**SUBJECT:** **DEMONSTRATION / DELIVERY HOLD – Compliance Recall 15C09 – Supplement #1**

Certain 2011-2013 and 2015 Model Year F-650 / F-750 Vehicles with 70% Fixed Seat Front Passenger Fixed Seat Restraint Anchorage Point

**REASON FOR THIS SUPPLEMENT**

*Provide labor allowances, parts ordering information and updated technical instructions to repair all affected vehicles.*

**FIGURE 3**

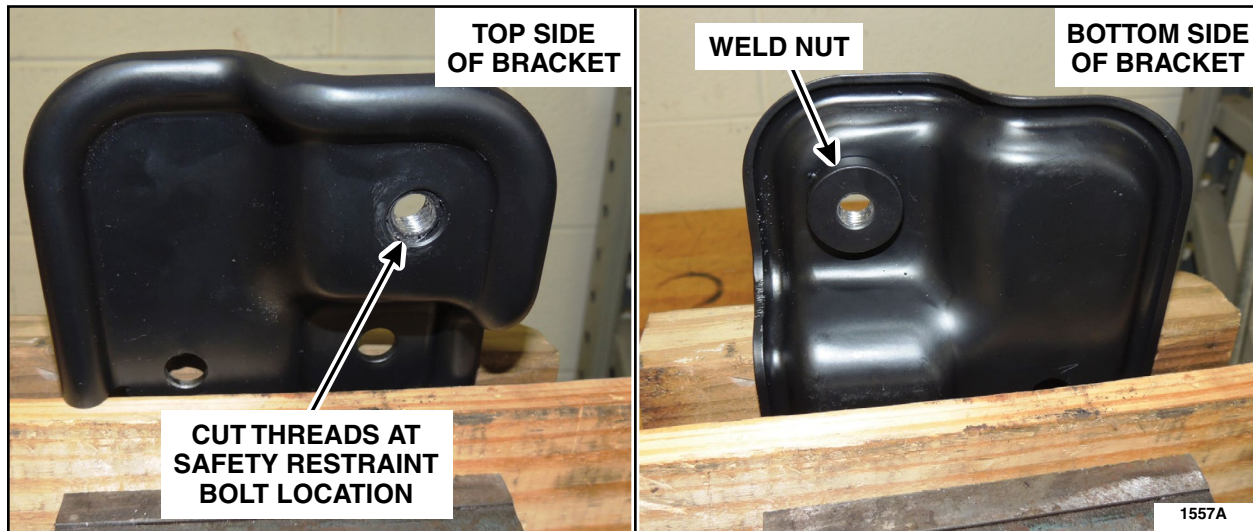
**NOTE:** Each bracket is equipped with a weld nut that uses self-tapping bolts to secure the restraint to the bracket. Threads must be cut in each weld nut prior to installing the brackets in the vehicle.

2. Use the *new* restraint bolts and an impact wrench to cut threads into the weld nut from the top side of each bracket. **DO NOT** allow the shoulder of the bolt to contact the bracket during this step. Use a bench vice to carefully secure the brackets during the thread cutting process. See Figure 3.

FIGURE 4

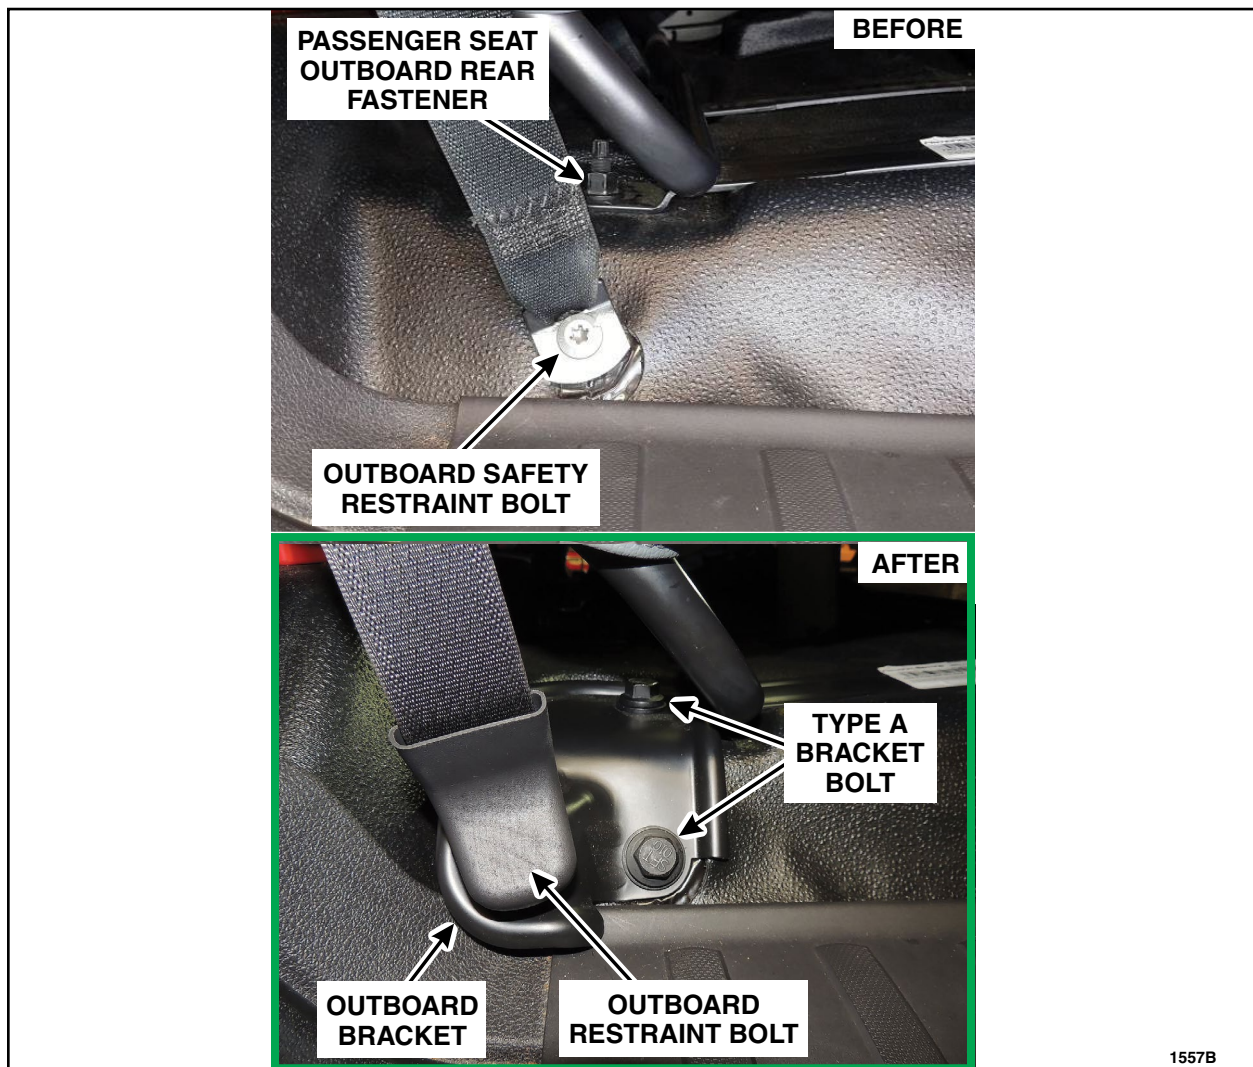
3. Install the outboard bracket (See Figure 4):

- a. Remove and discard the outboard safety restraint bolt and the passenger seat outboard rear fastener.

**NOTE:** If the passenger seat outboard rear fastener is secured with a stud and nut, the stud must also be removed and discarded.

- b. Install the outboard bracket as shown with *new* bolts.

- Install a type A bracket bolt in the original restraint location and tighten to 30 lb.ft (40 Nm).
- Install a type A bracket bolt in place of the original seat fastener and tighten to 41 lb.ft (55 Nm).

- c. Install the safety restraint and *new* outboard restraint bolt to the relocation bracket and tighten to 30 lb.ft (40 Nm).

FIGURE 5

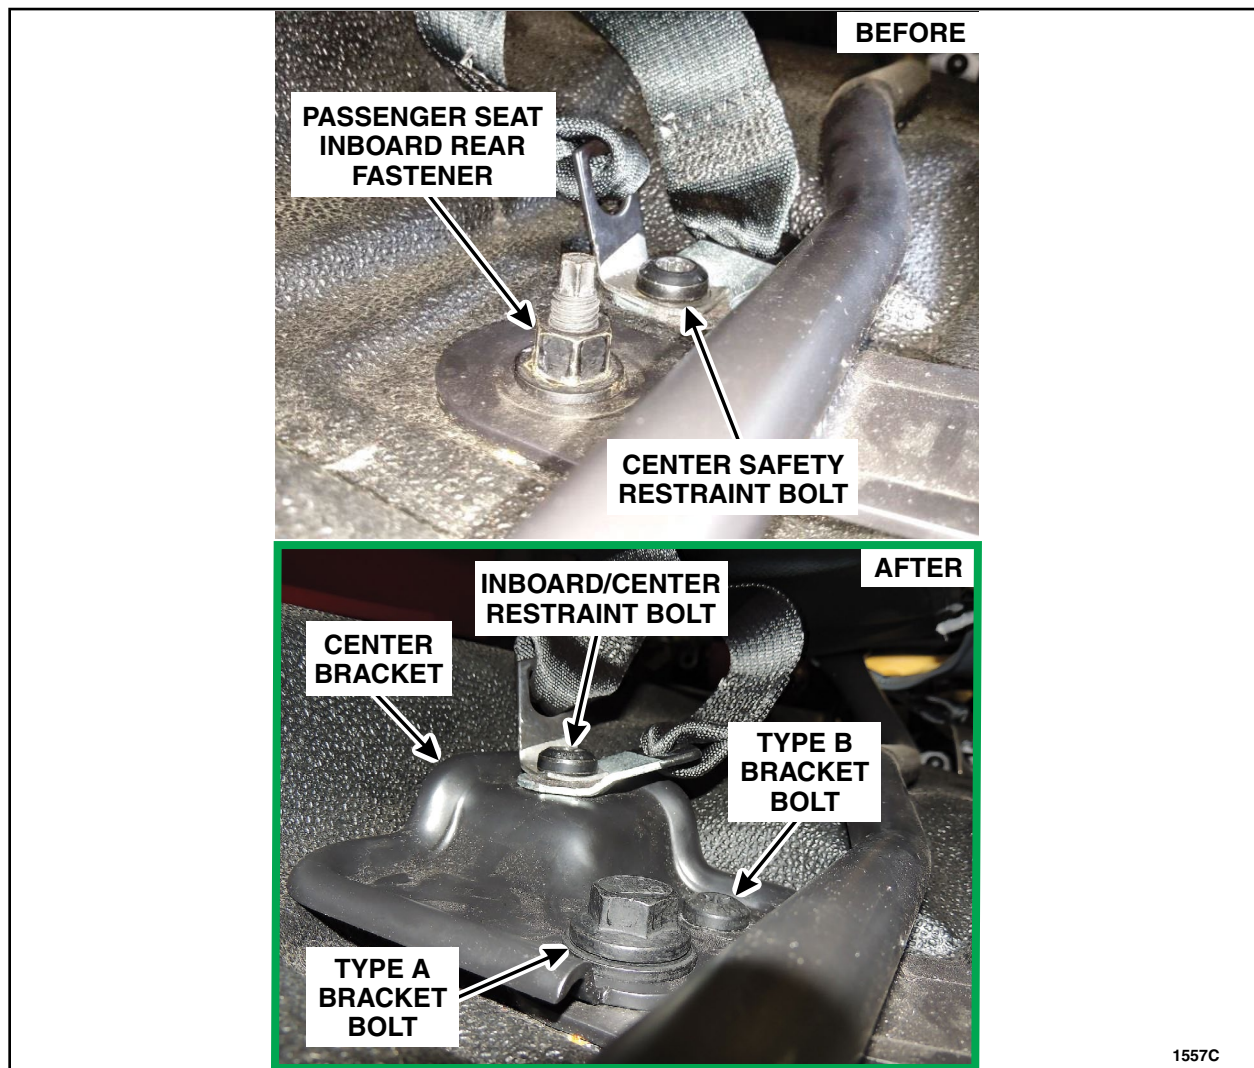
4. Install the center bracket (See Figure 5):

- a. Remove and discard the center safety restraint bolt and the passenger seat inboard rear fastener.

**NOTE:** If the passenger seat inboard rear fastener is secured with a stud and nut, the stud must also be removed and discarded.

- b. Install the center bracket as shown with a *new* type B bracket bolt in the original restraint location, and a *new* type A bracket bolt in place of the original seat fastener. Tighten both bolts to 41 lb.ft (55 Nm).

- c. Install both safety restraints and *new* inboard/center restraint bolt to the center bracket and tighten to 41 lb.ft (55 Nm).

FIGURE 6

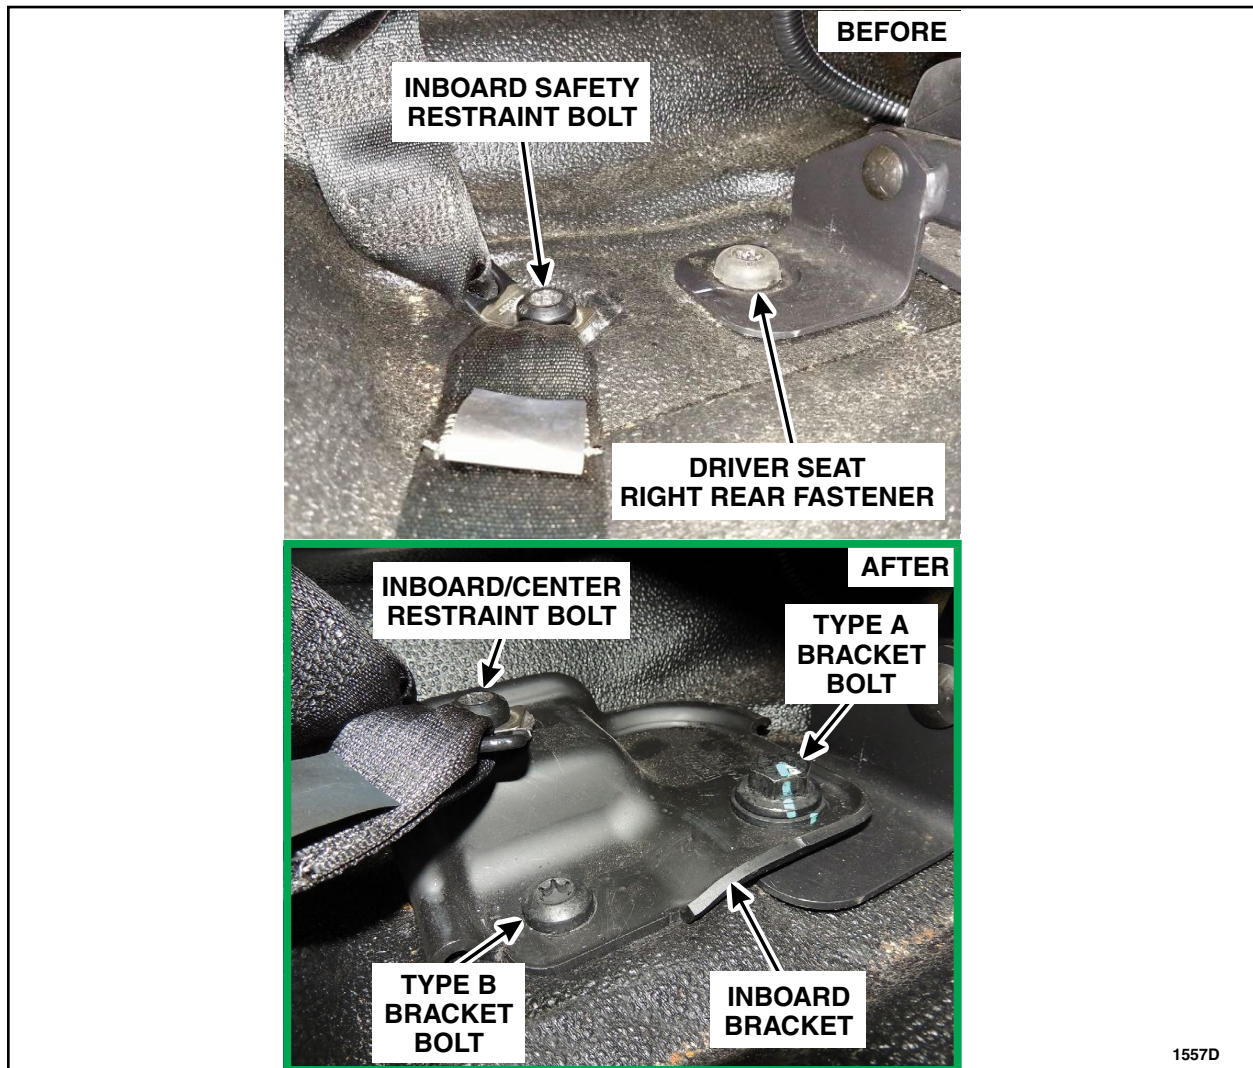
5. Install the inboard bracket (See Figure 6):

a. Remove and discard the inboard safety restraint bolt and the driver seat right rear fastener.

**NOTE:** If the driver seat right rear fastener is secured with a stud and nut, the stud must also be removed and discarded.

b. Install the inboard bracket as shown with *new* bolts.

- Install a type B bracket bolt in the original restraint location and tighten to 30 lb.ft (40 Nm).
- Install a type A bracket bolt in place of the original seat fastener and tighten to 41 lb.ft (55 Nm).

c. Install the safety restraint and *new* inboard/center restraint bolt to the relocation bracket and tighten to 30 lb.ft (40 Nm).
